Product Change Notification: E-17-006995

Heavy Duty Sealed Connector

New tool for COVER 90 DEGREE 1563110, 1670057, 1670150, 1670865 The drawings for the listed part numbers have been modified for clarification

Picture:

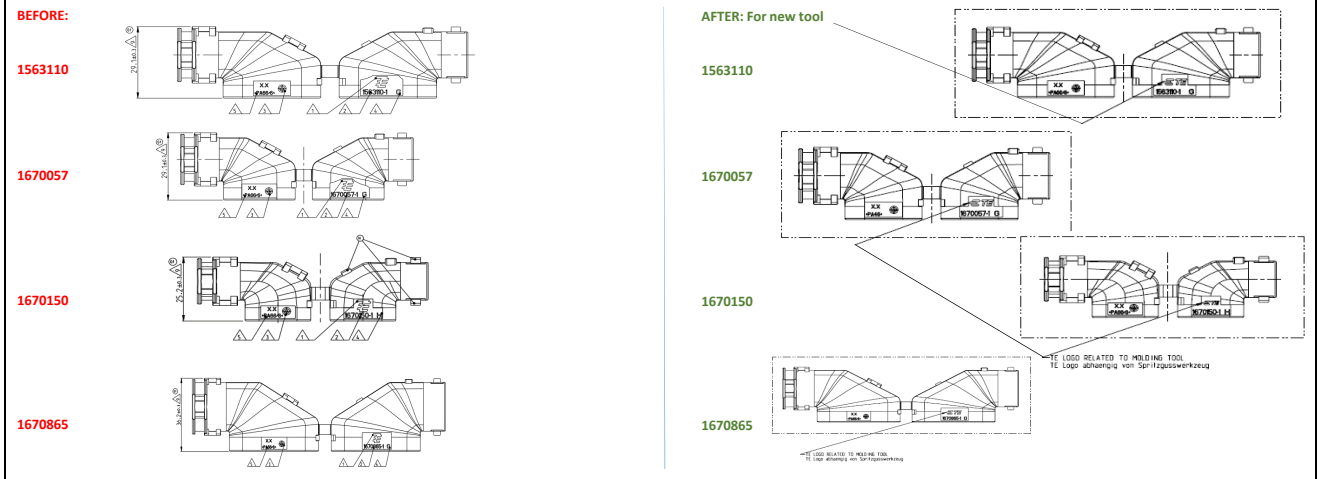
Product Improvement. Additional tool necessary because of replacement and duplication. For further detailed Information please ask Steffen.Gilch@te.com
